Edith Cherry D. James See Architects 220 A. Gold Bldg. Albuquerque, New Mexico, 87102 505 842 1278	
CITY OF ALBUQUERQUE DEPT. OF MUNICIPAL DEVELOPMENT PARK DESIGN & CONSTRUCTION DIVISION	
TITLE: PHIL CHACON PARK - NM VETS MEMORIAL PHASE VIII GRADING PLANS	
Design Review Committee	City Engineer Approval
Last Design Update	NO./DAY/YR. NO./DAY/YR.
City Project No. 638098	Zone Map No. L-19-Z
Sheet C-101	Of

Edith Cherry D. James See Architects 220 A. Gold SW Albuquerque, New Mexico, 87102 505 842 1276	
CITY OF ALBUQUERQUE DEPT. OF MUNICIPAL DEVELOPMENT PARK DESIGN & CONSTRUCTION DIVISION	
TITLE: PHIL CHACON PARK - NM VETS MEMORIAL PHASE VIII	
Design Review Committee	City Engineer Approval
City Project No. 638098	Zone Map No. L-19-Z
Last Design Update	Sheet L-101A

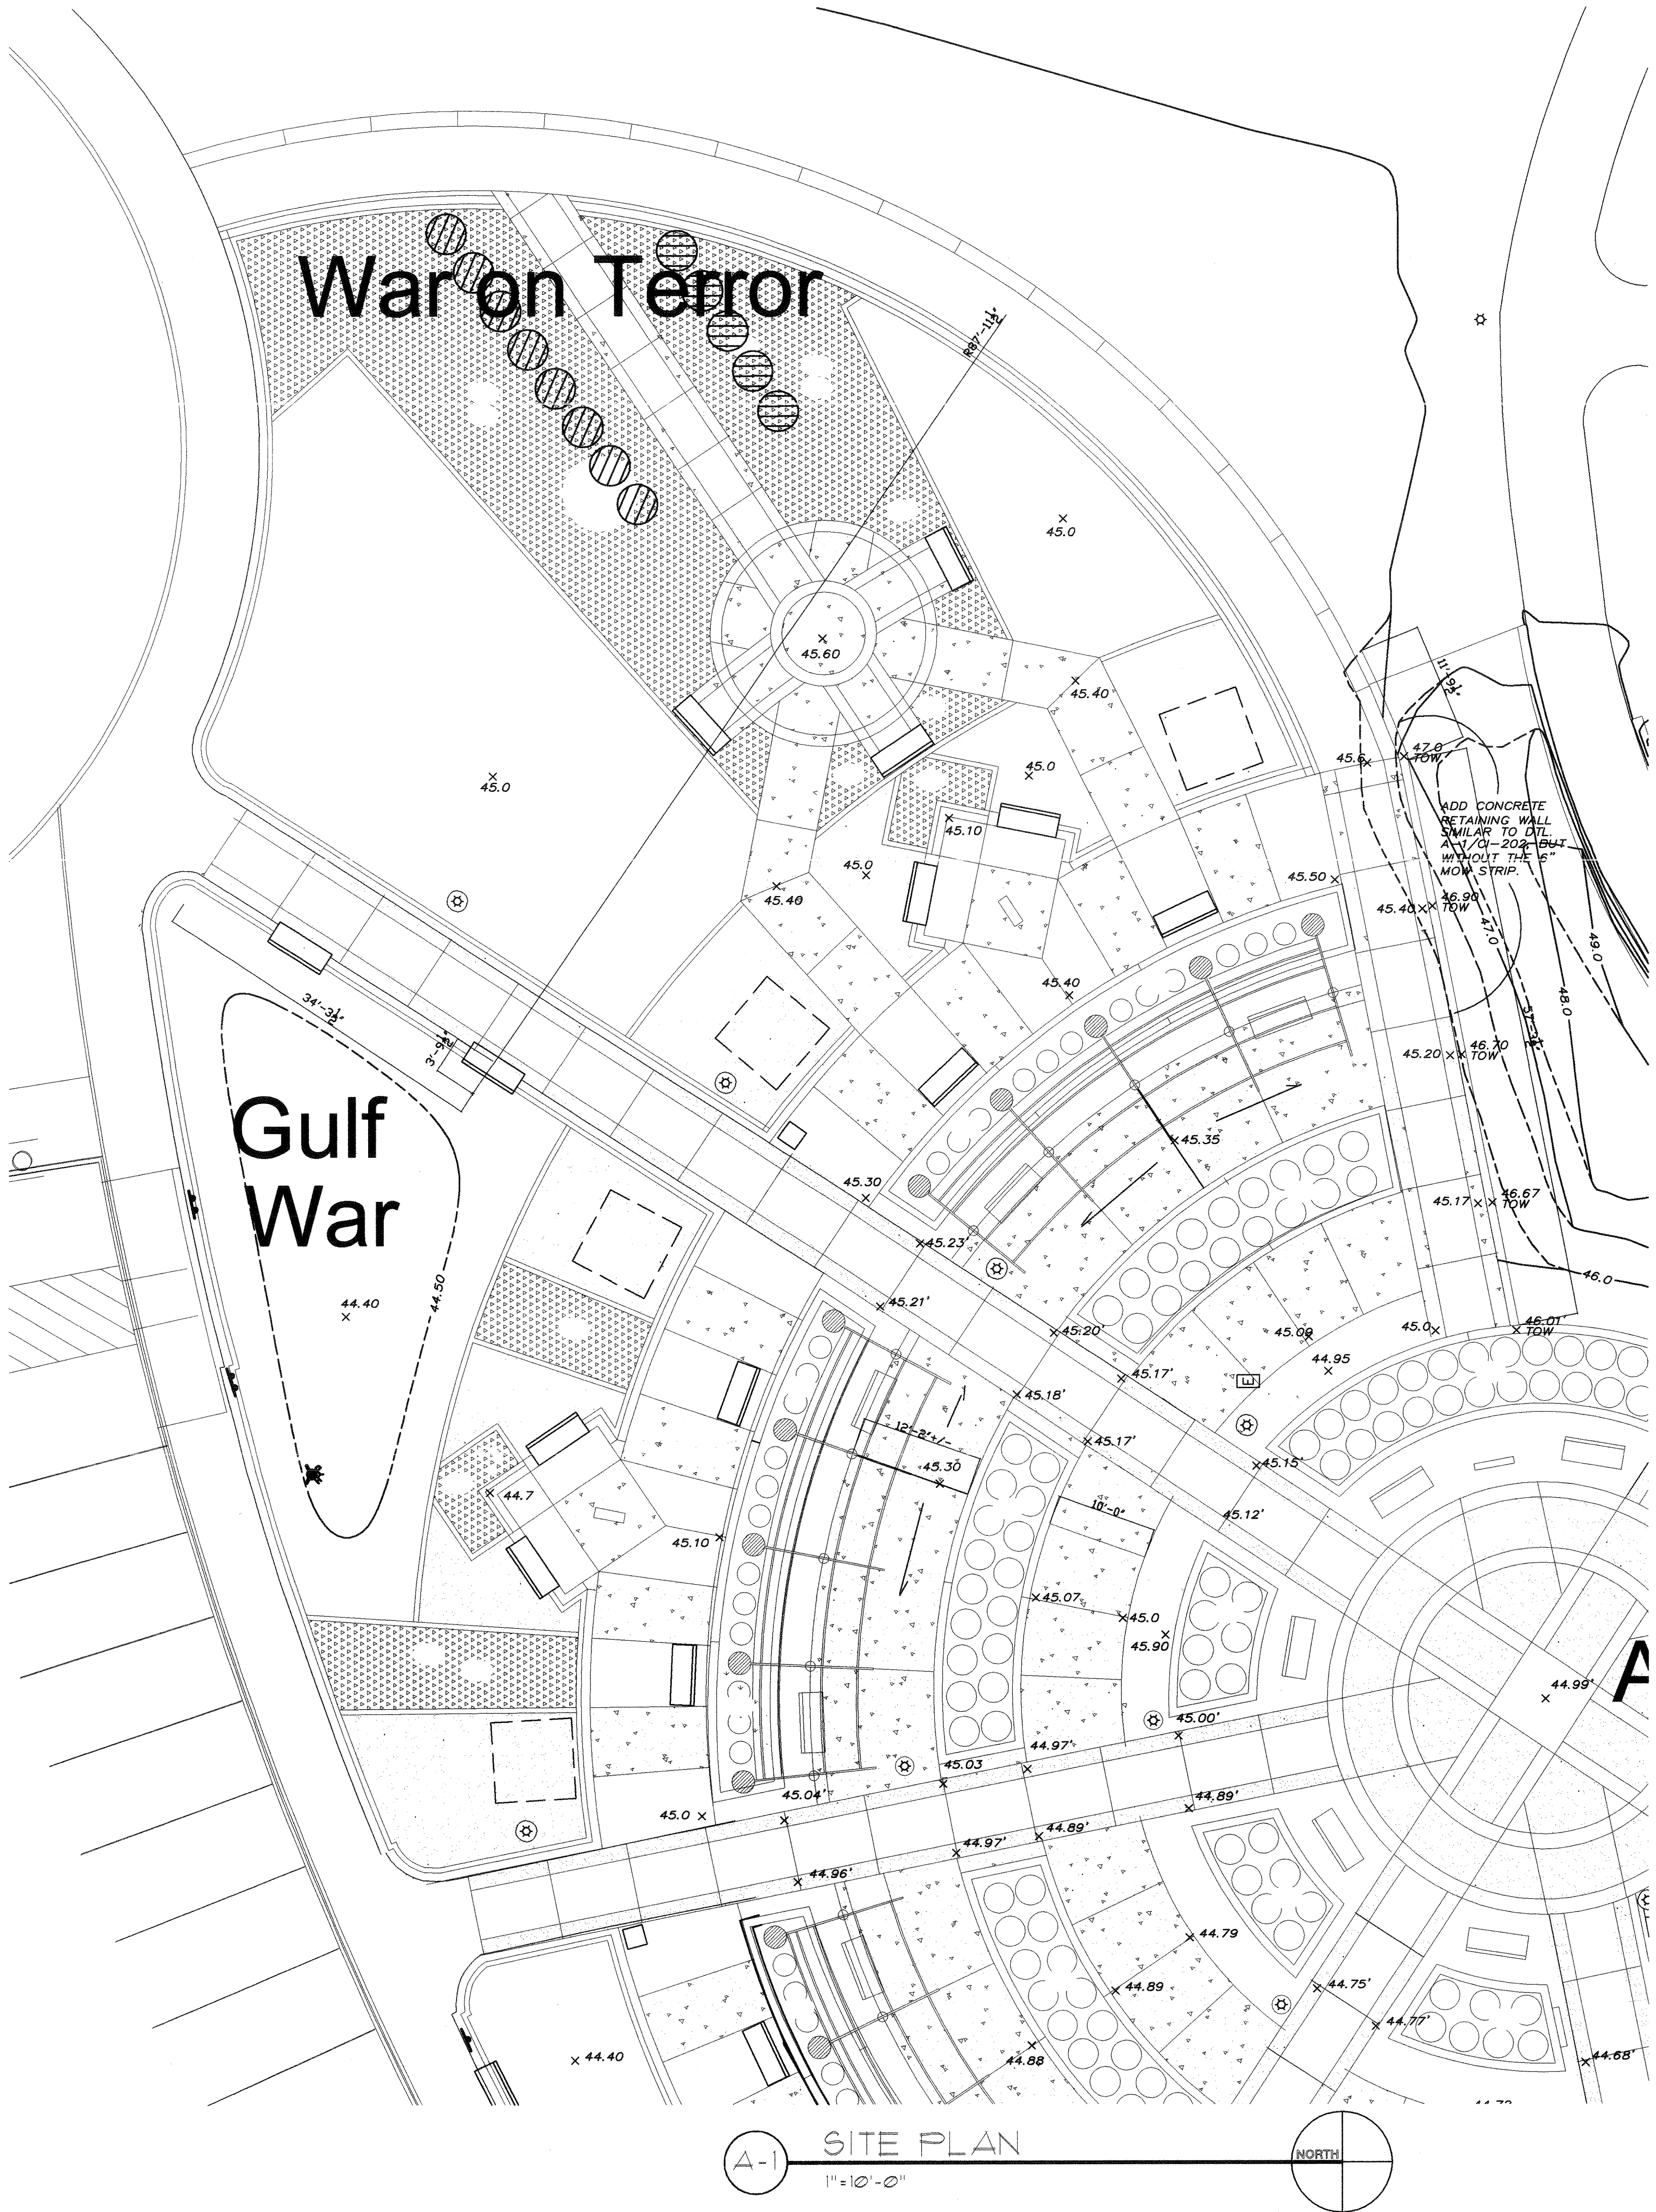
NOTE: ADDITIONAL DIMENSIONS HAVE BEEN GIVEN AND CONCRETE INSIDE ROSE GARDEN HAS BEEN REVISED TO PROVIDE POSITIVE DRAINAGE TO REMAINING CRUSHER FINE AREAS SO THAT PONDING IS REDUCED ON THE HARD SURFACES. ALSO A RETAINING WALL HAS BEEN ADDED.

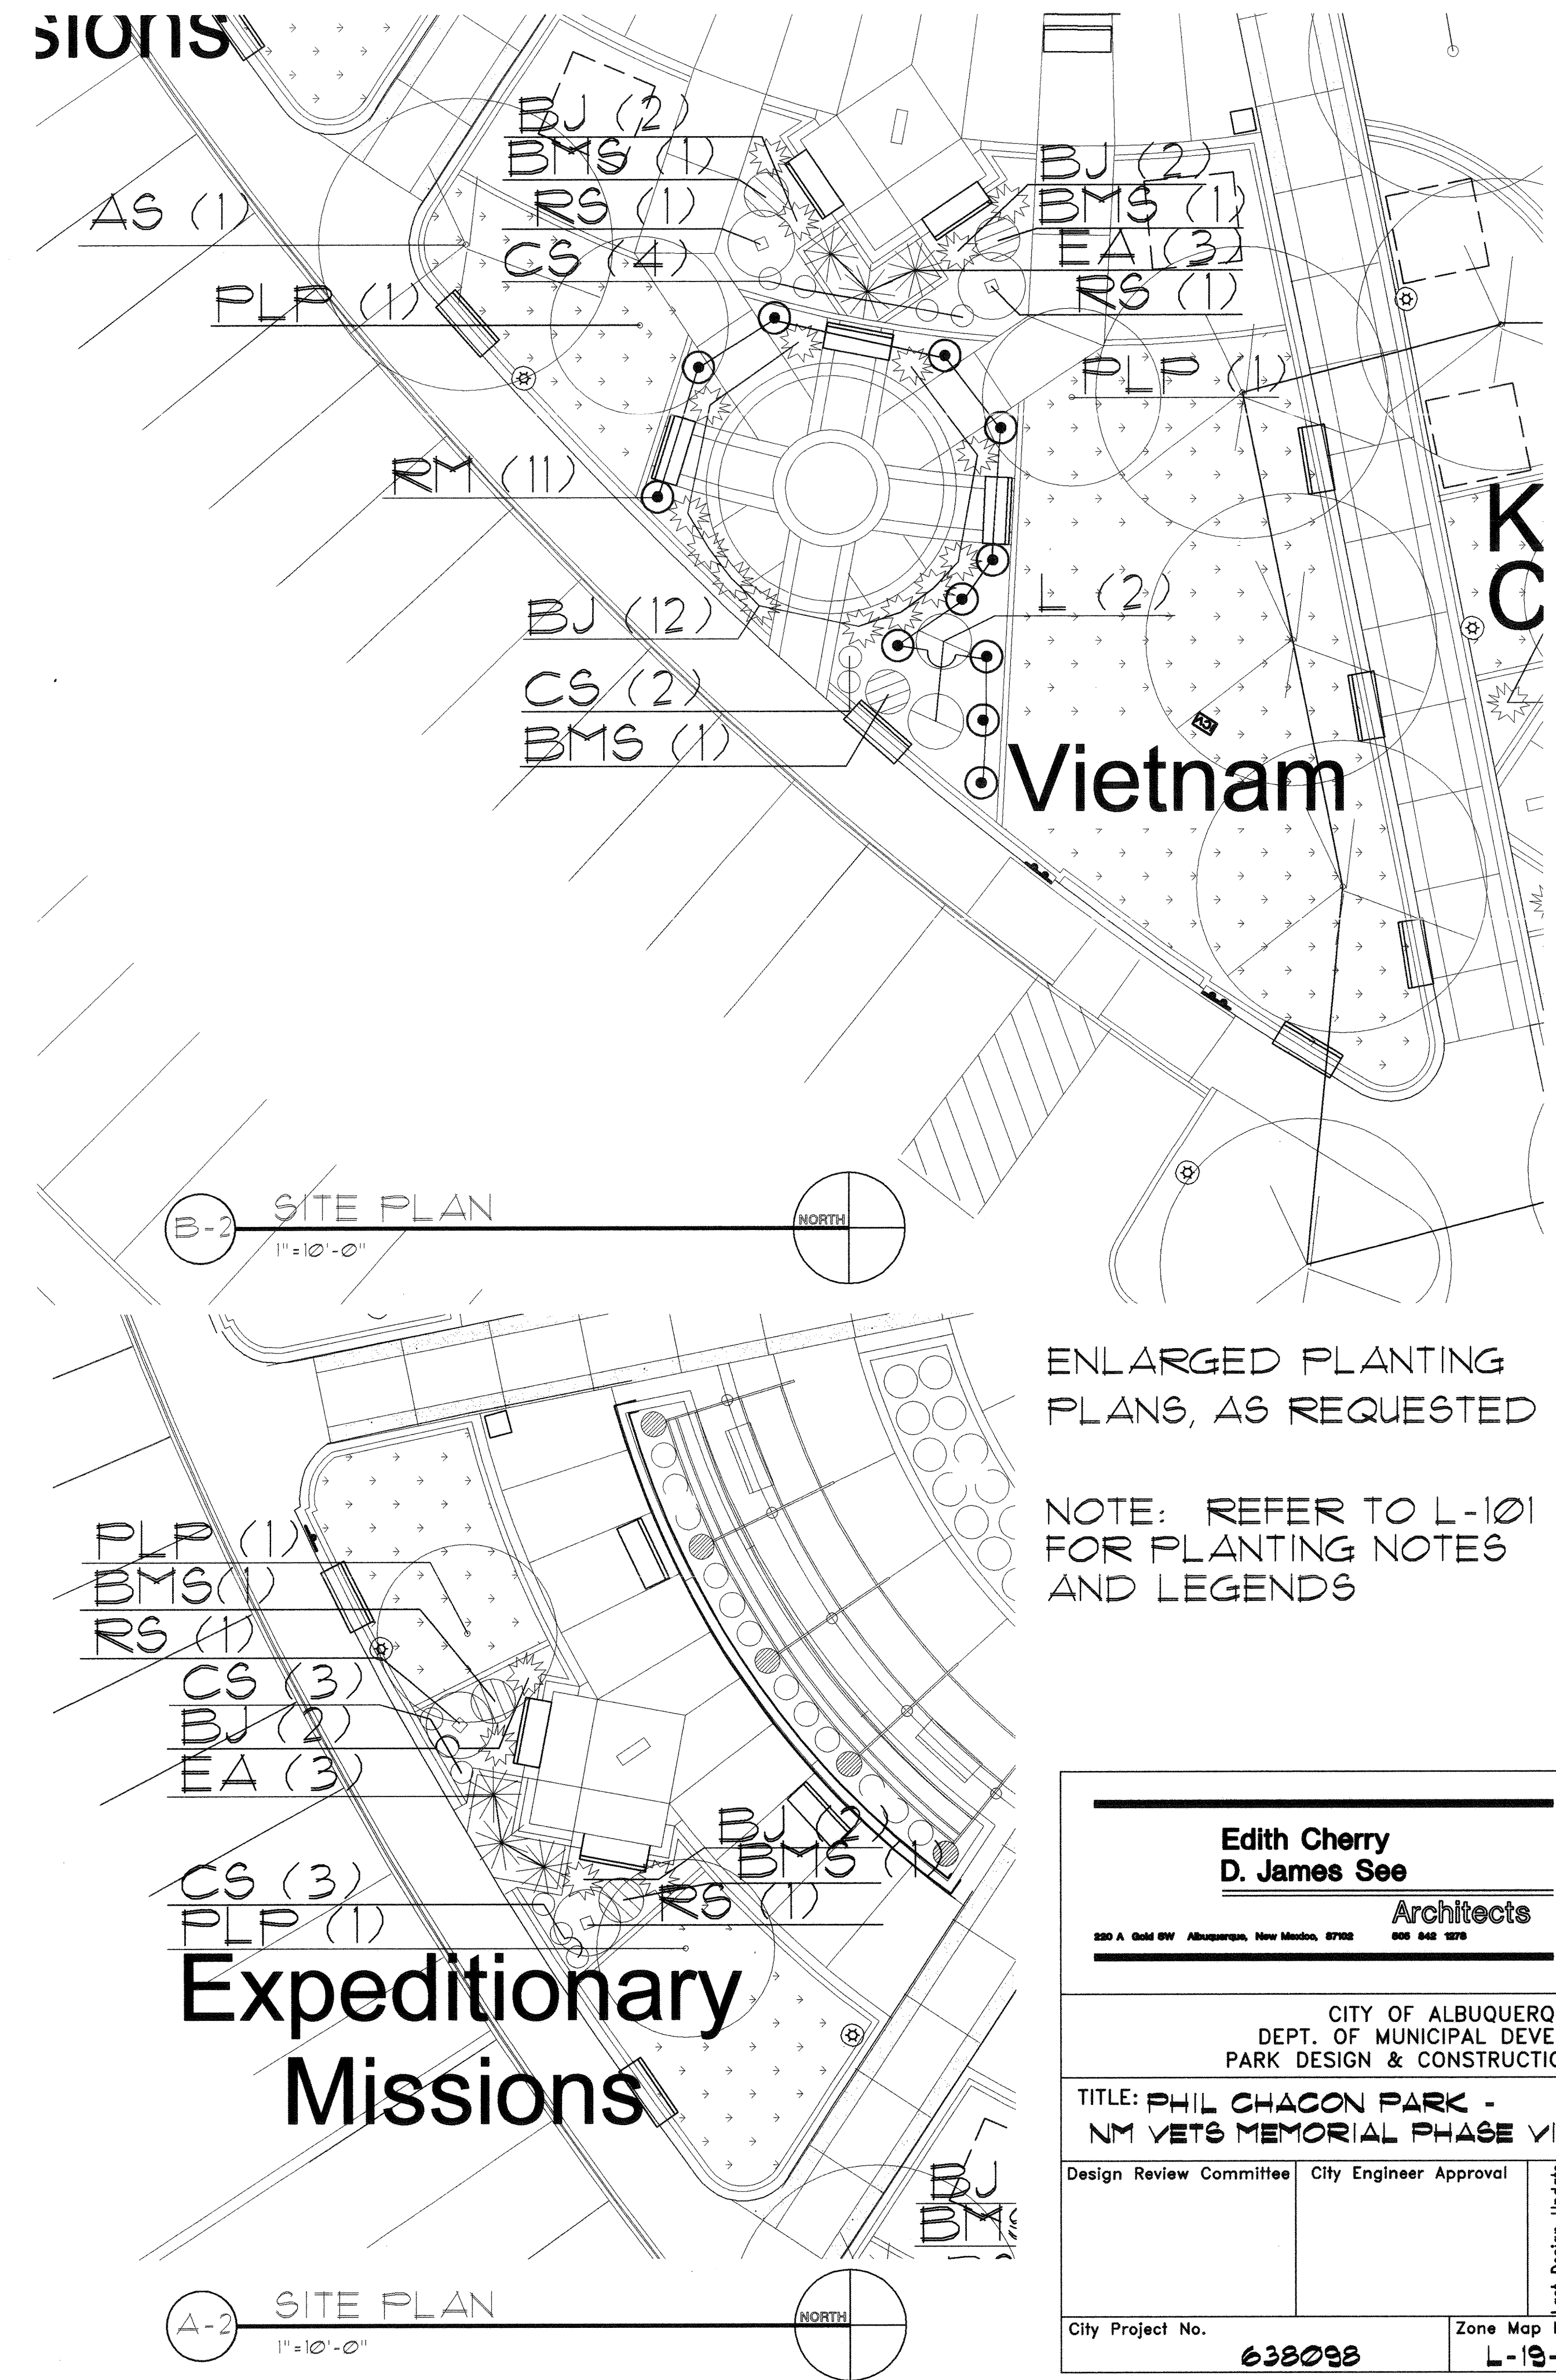
ENLARGED PLANTING
PLANS, AS REQUESTED
